16_41 Seeding Reports Errors in Mountainous Areas

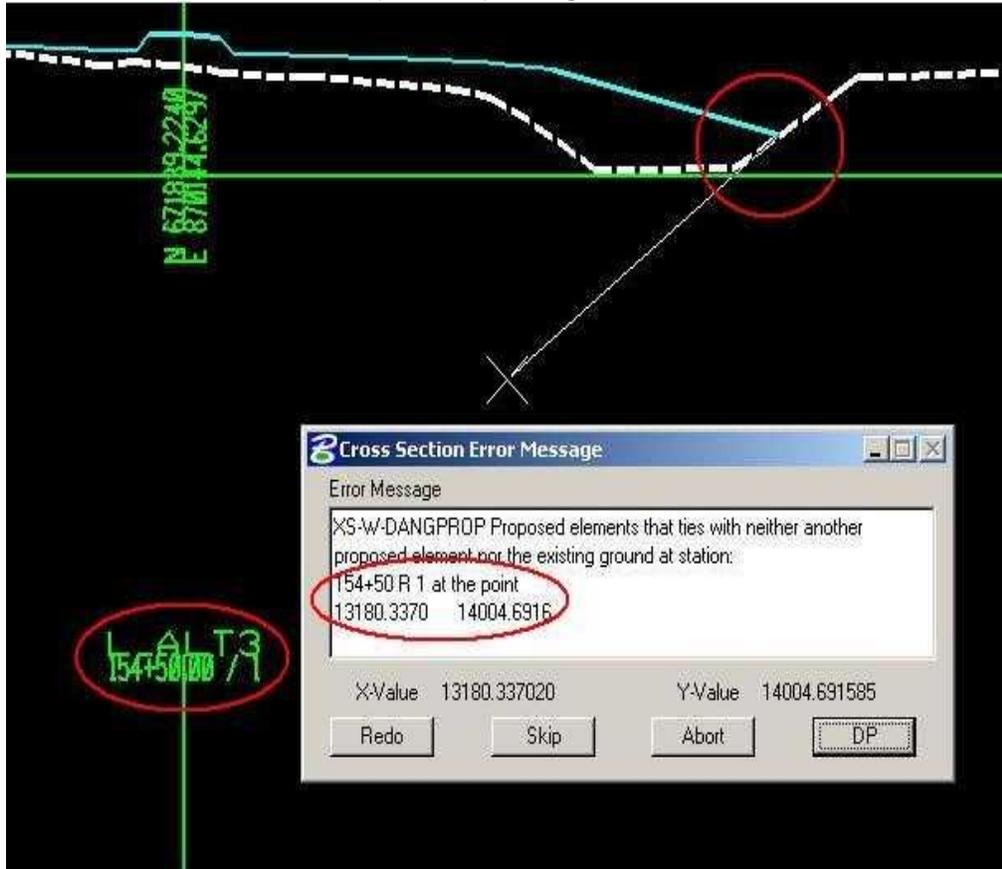
Having problems running the seeding report for some stations. *example 154+00, 154+50...

The error message pertains to "Dangling" proposed elements not connecting to existing ground or to another proposed element. This is half right. Look at the picture below. The error states that the problem is at station 154+50 but the DP points is pointing to the tie at 155+00.

This a common problem on mountainous jobs where the green cross section cells are close to each other due to the drastic elevation differences. My recommendation is to copy the xsc file, and just for seeding report only, in the station ranges where the green cells are within 100' to each other, move them apart vertically.
